## PHASE 2 - WESLEY BRADLEY PARK

EXISTING SITE AND TESC PLAN NORTH  
FOR  
CIVIL PLANS  
PHASE 2 - WESLEY BRADLEY PARK

Job Number  
16718  
Sheet  
C2 of 19

CONSTRUCTION NOTES & DETAILS  
FOR  
**PHASE 2 - WESLEY BRADLEY PARK**

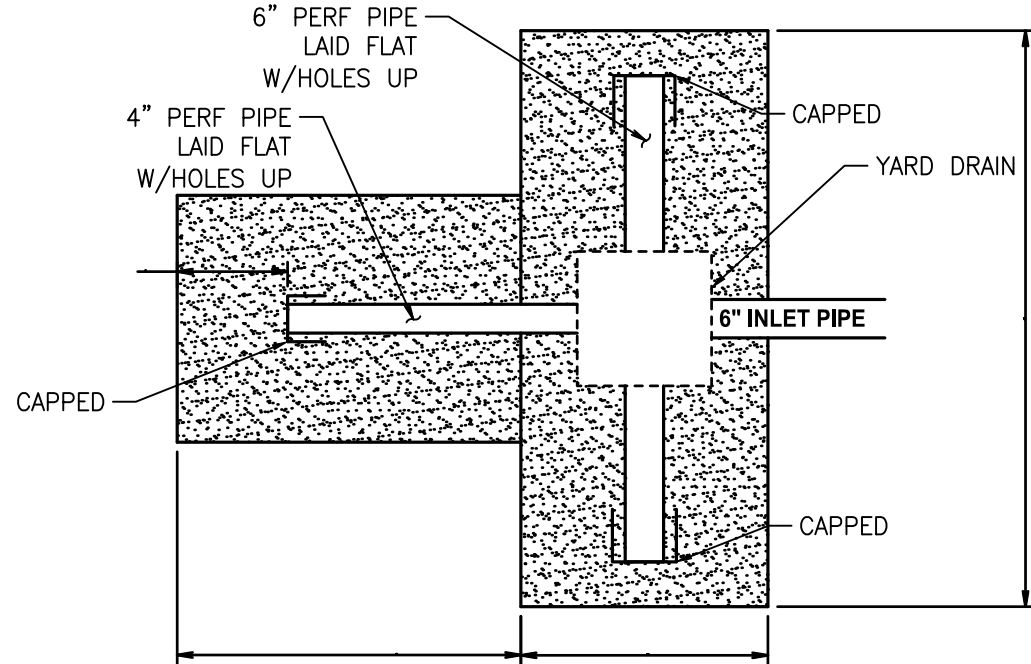
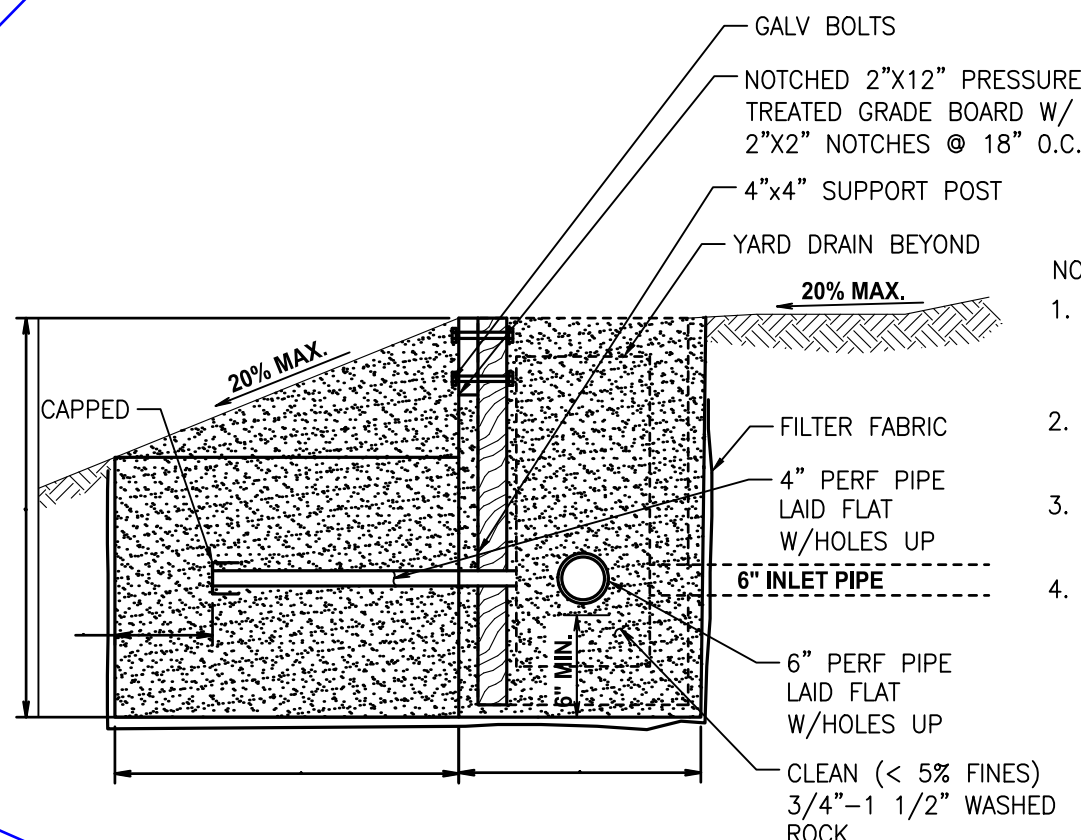
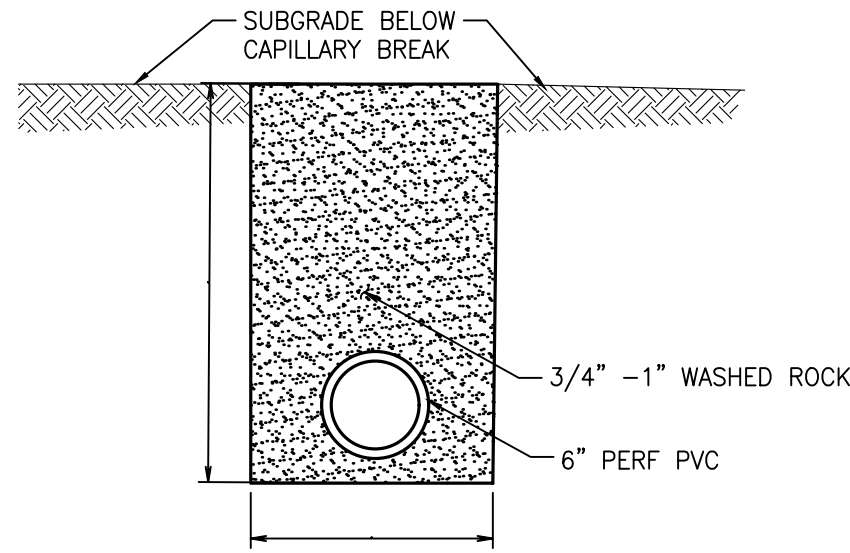
Provide dimensional info for these sections.  
[Plans; Sht C16 of 19]

WATER DETAILS  
FOR  
**PHASE 2 - WESLEY BRADLEY PARK**

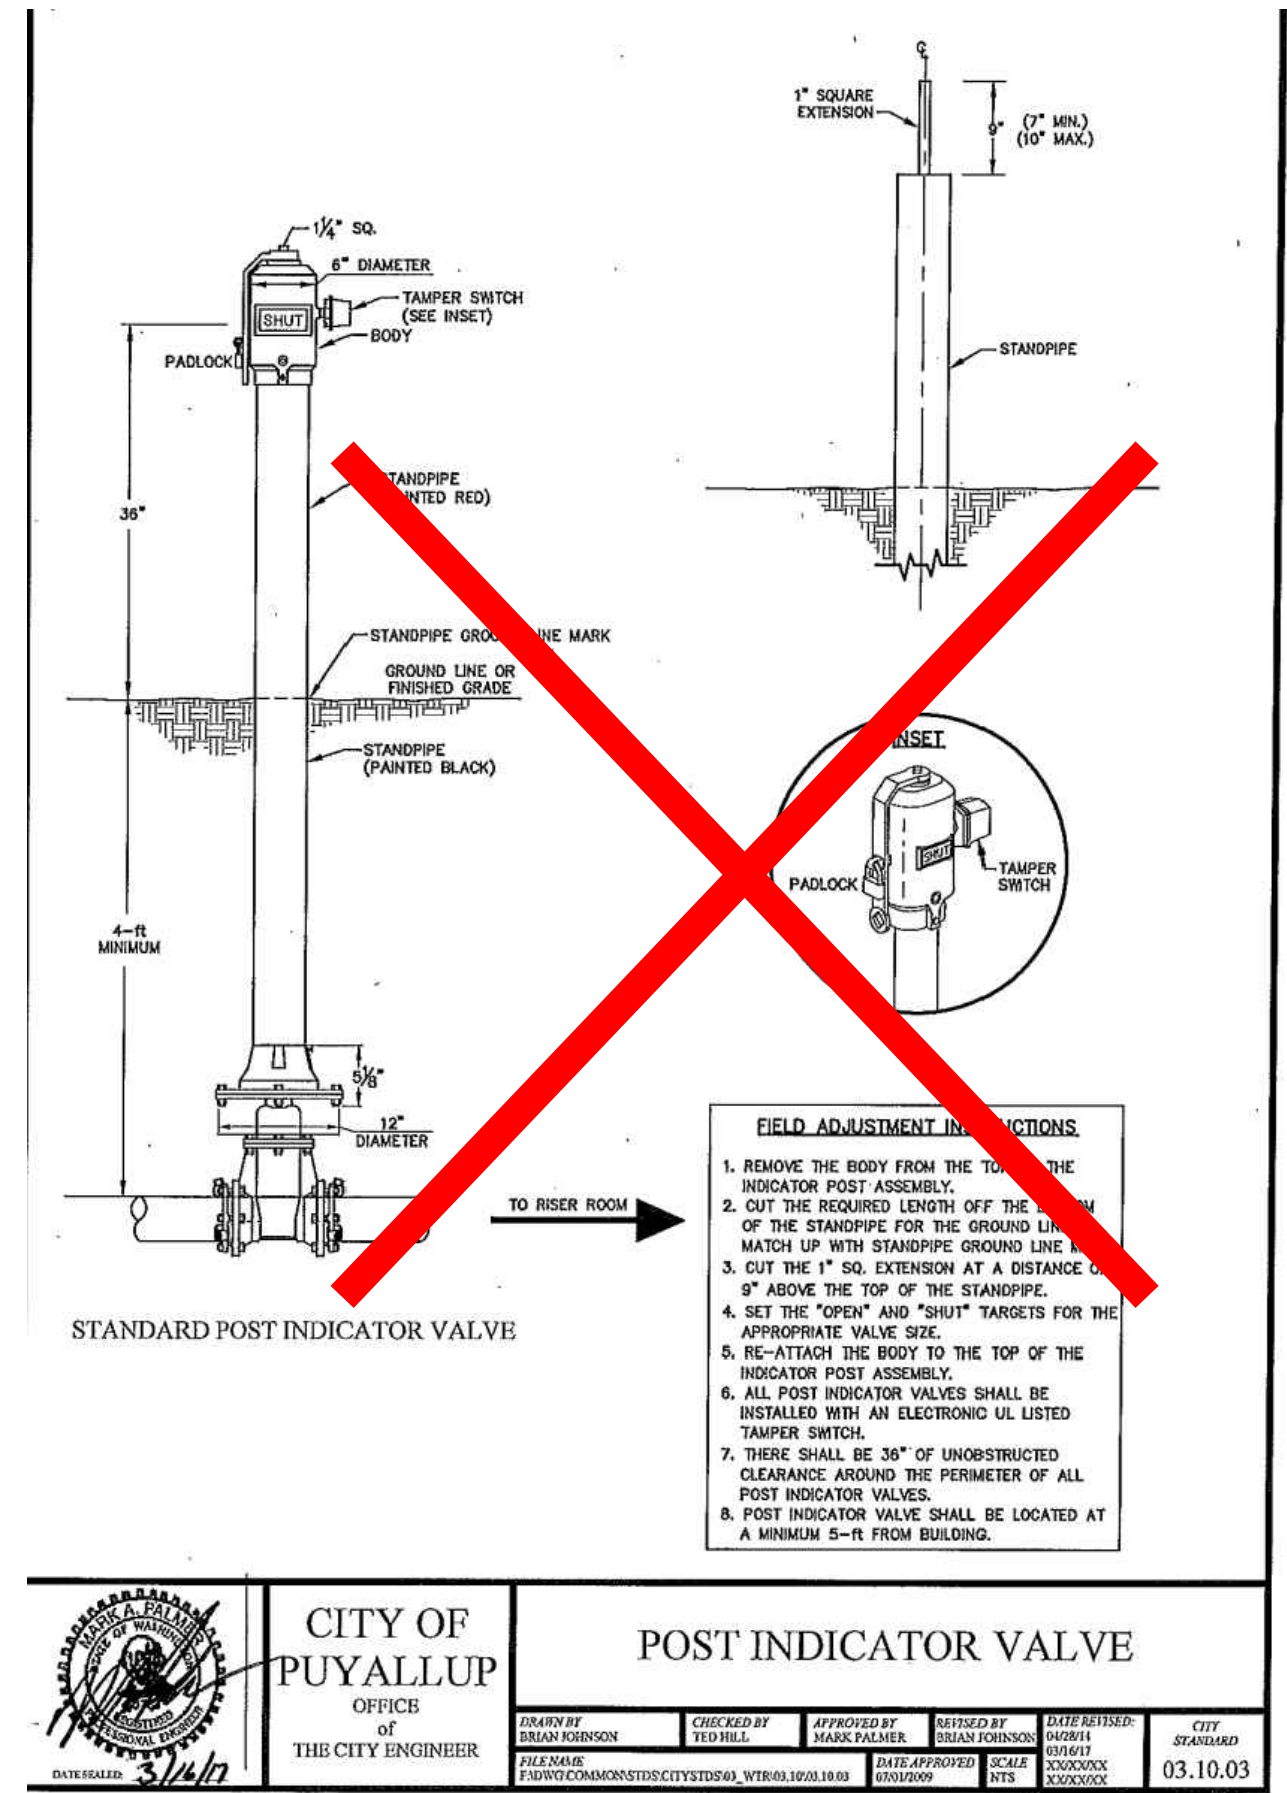
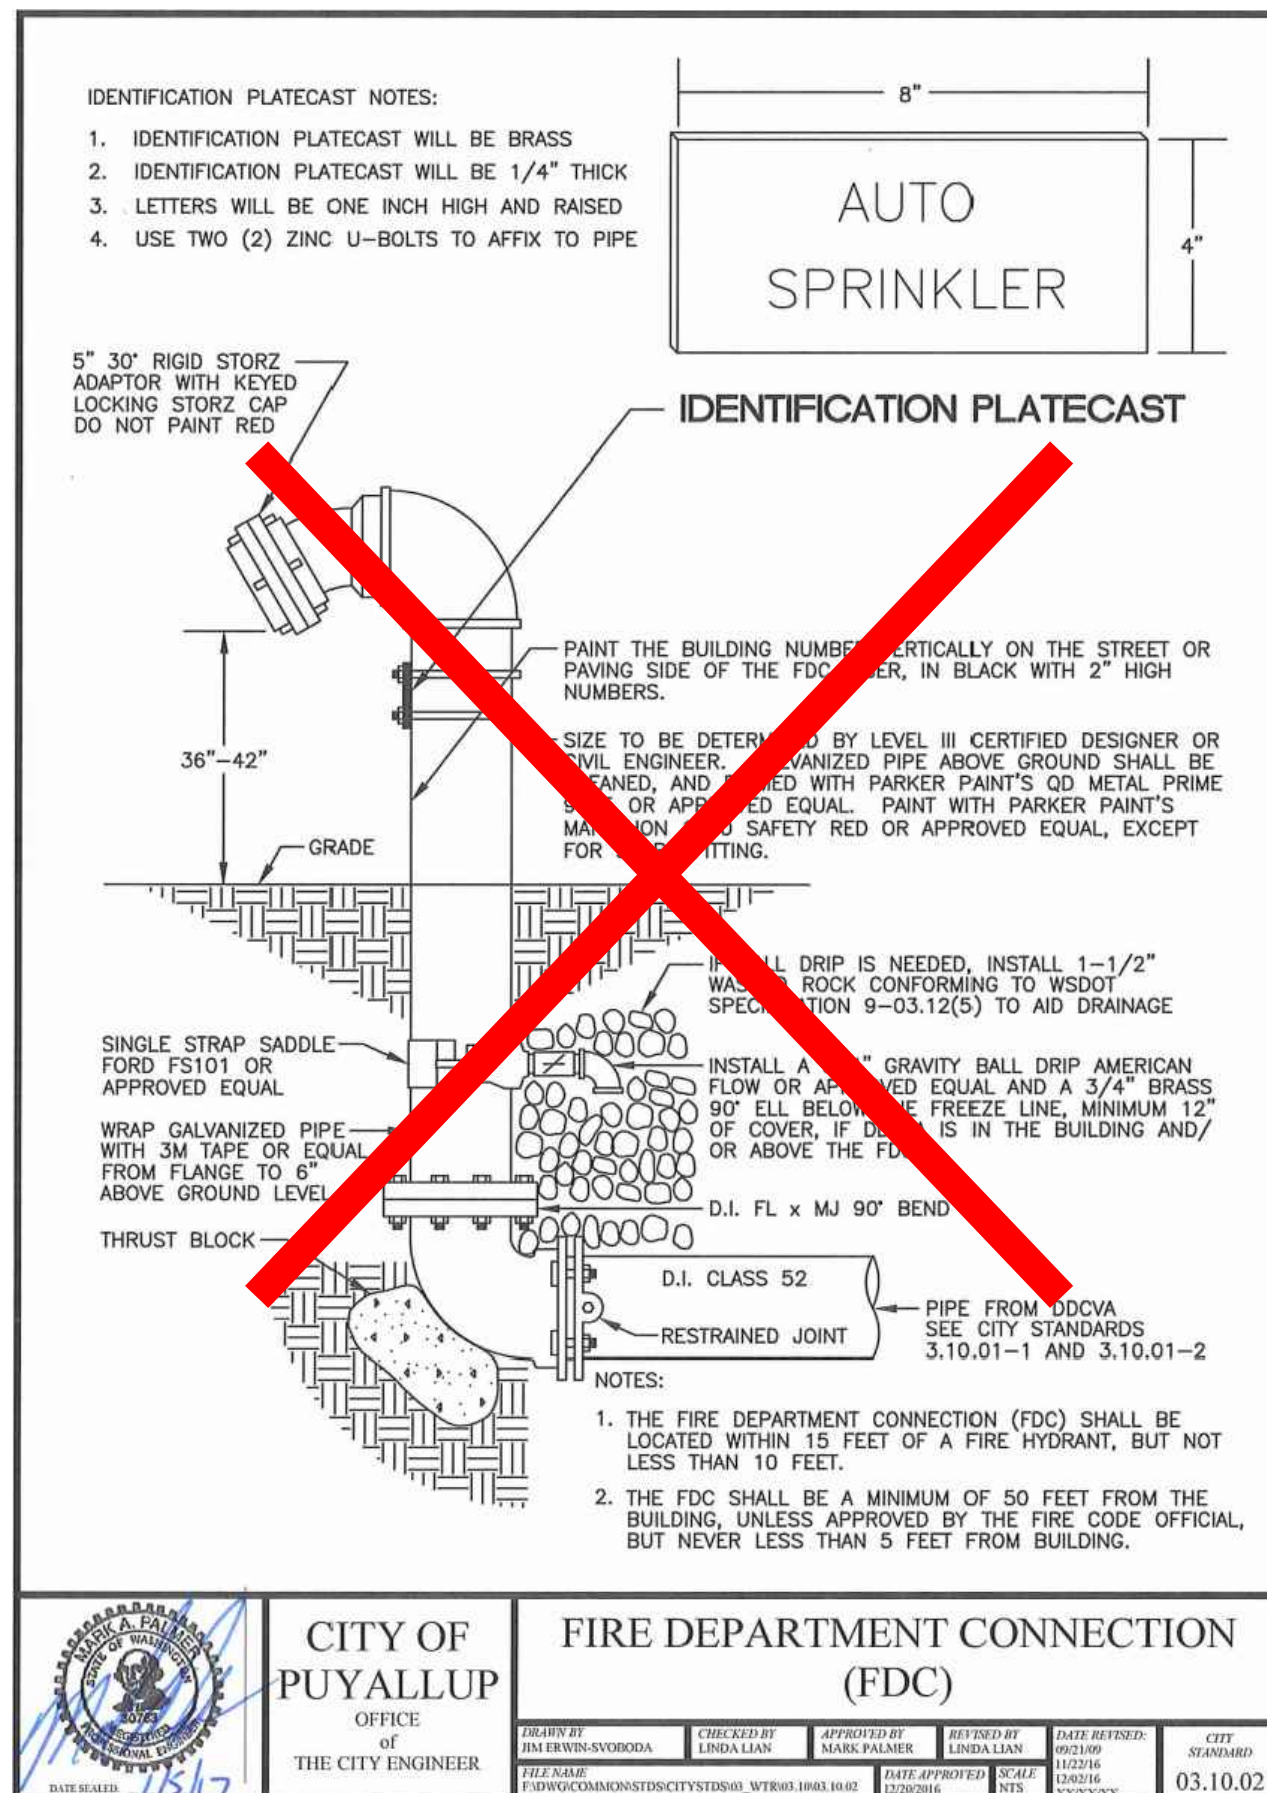
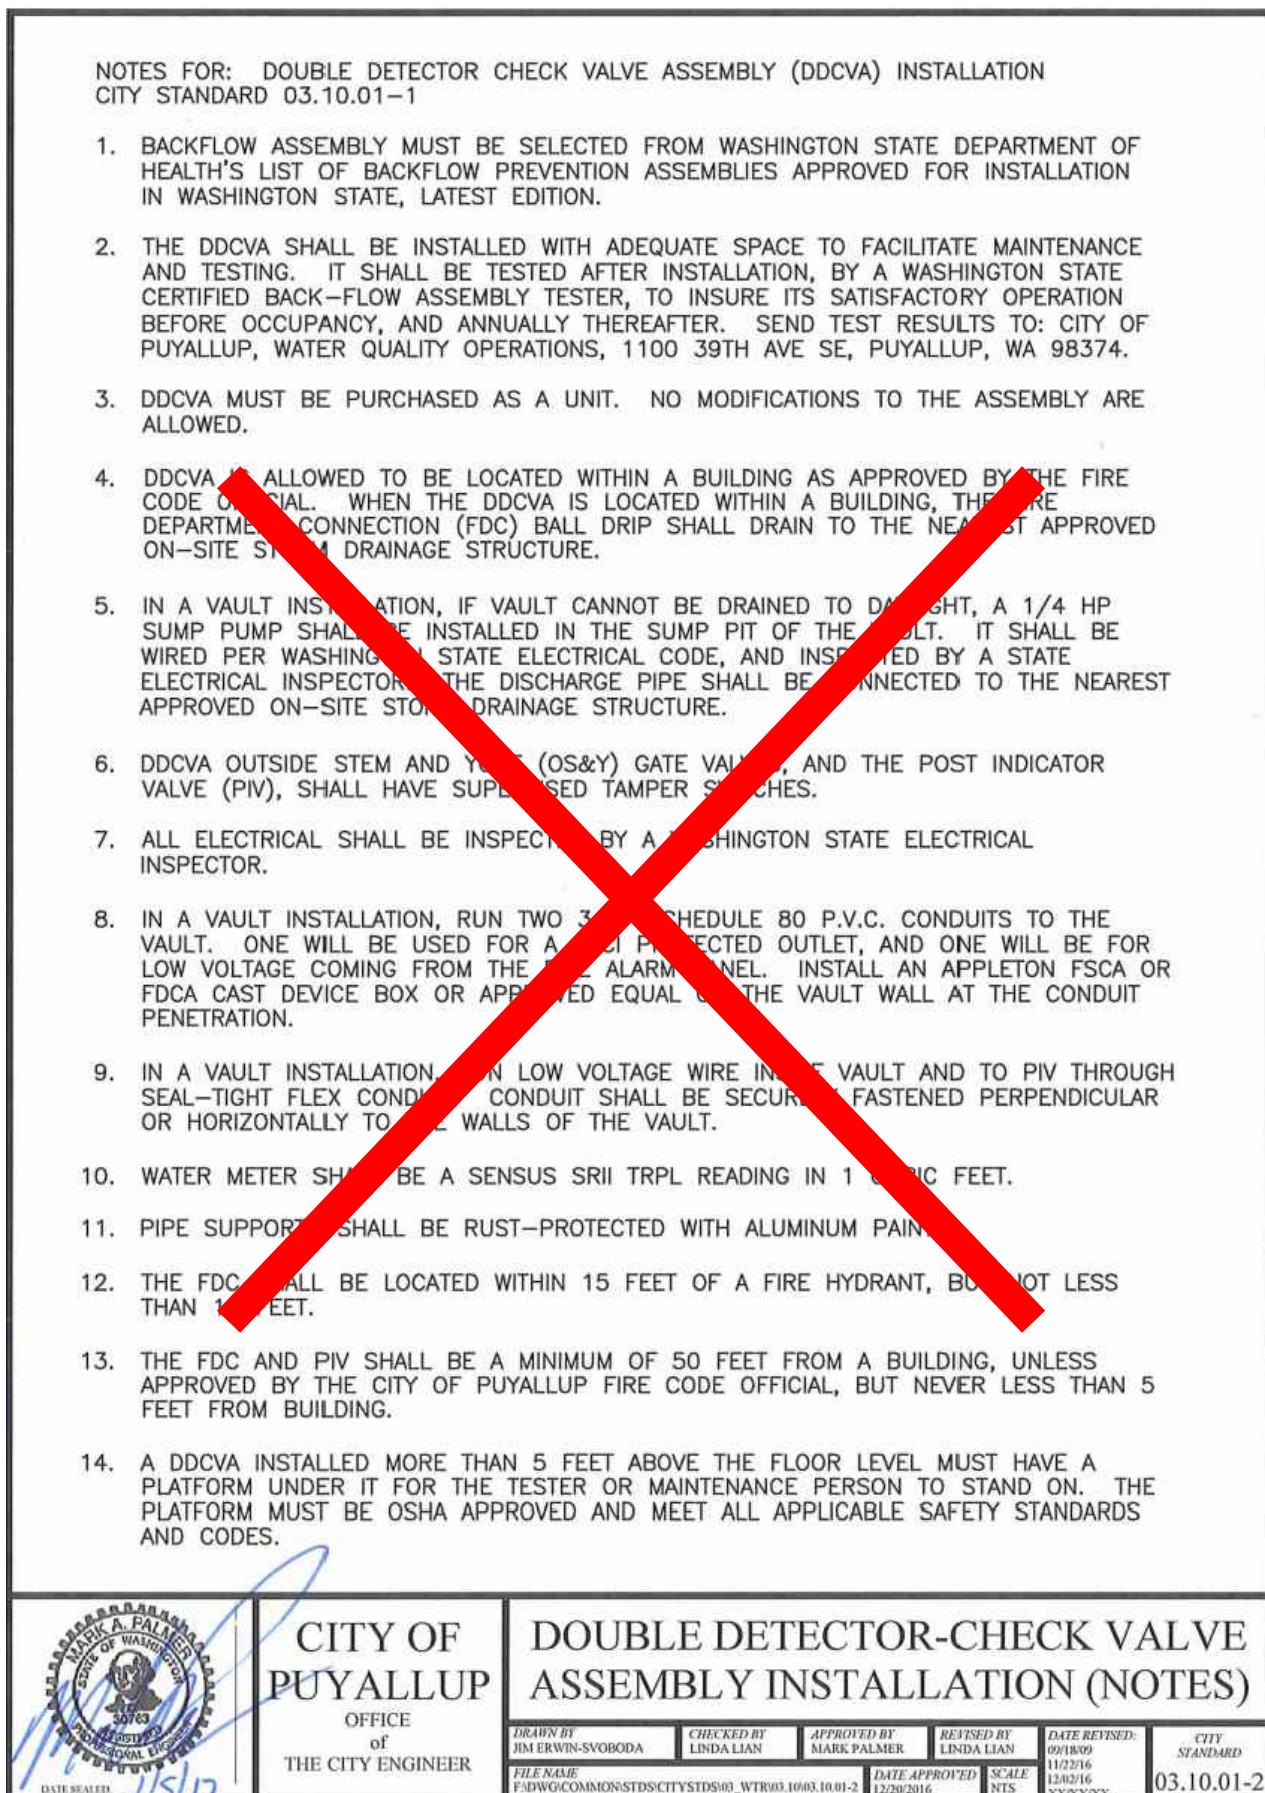
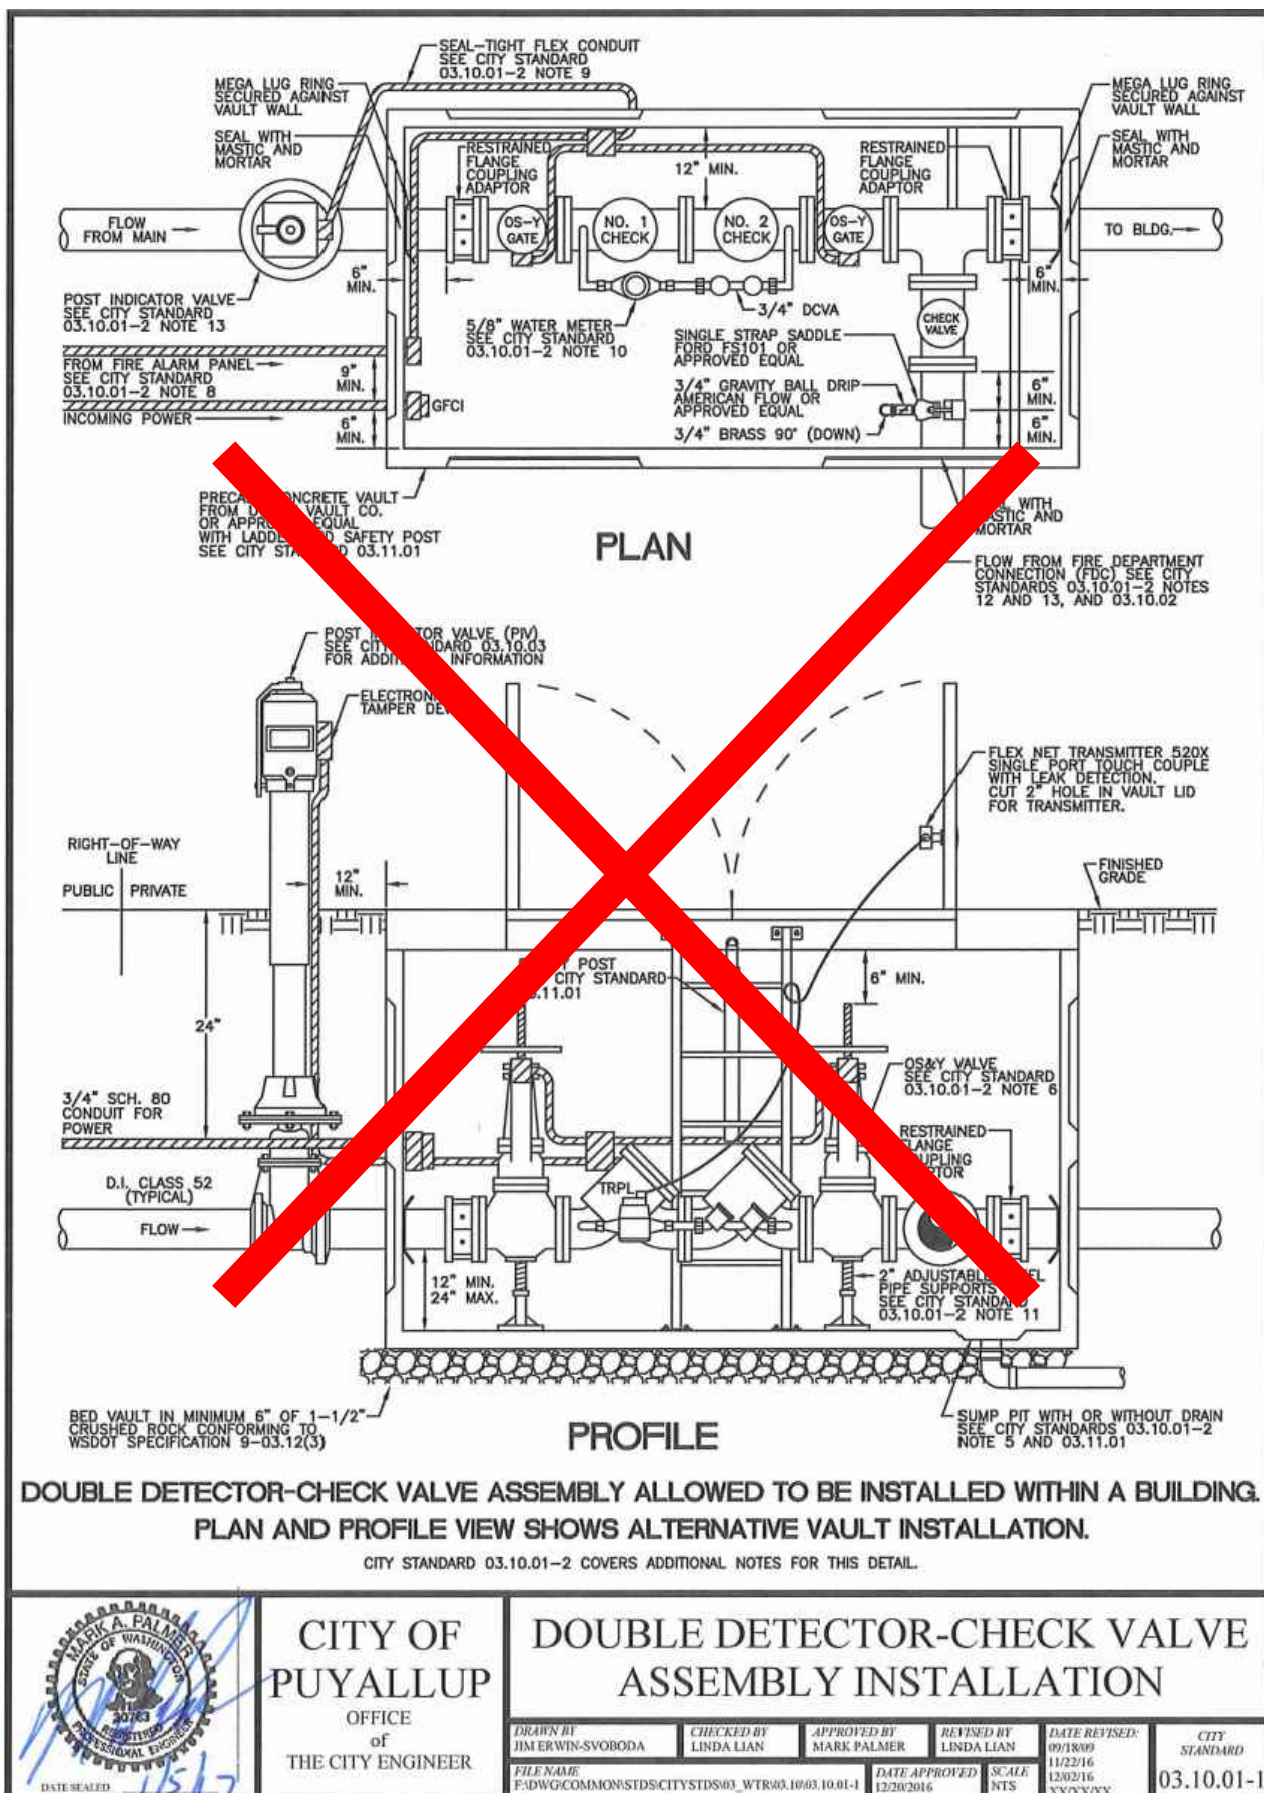
Update all of these details to current standard.  
[Plans: Sht C17 of 19]

Civil Sheet C17: Remove this standard detail. It is not needed for this project.
